## Change To Product December 1995 Drawstring Neck Dam Alteration for Fit

Products Affected: Kirby Morgan SuperLite-17 A/B & U.S. Navy MK-21 Mod.O & Mod.I Helmets

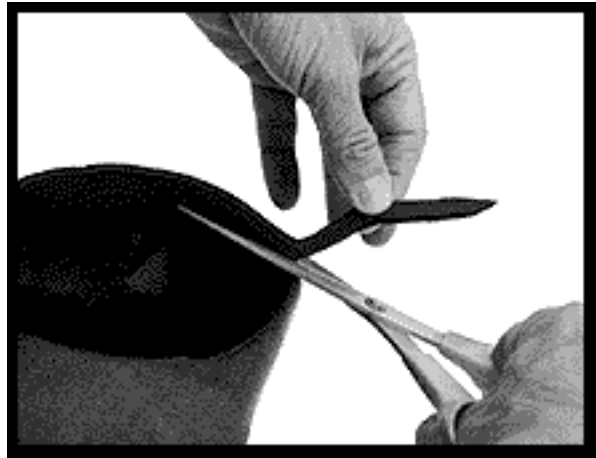
The neck chute of the dam is now angled, allowing the helmet to rest in a more comfortable position and lessening front end ride up. It also fits a wider variety of neck sizes.

If the Neck Dam is too tight on the neck or too hard to get over the head, the Neck Dam **MUST BE TRIMMED**. Trim 1/4 inch at a time, as shown, until the proper fit is attained. Do not trim more than 1/4 inch at a time. Do not use a loose fitting Neck Dam. It will allow leakage and possible flooding into the helmet.
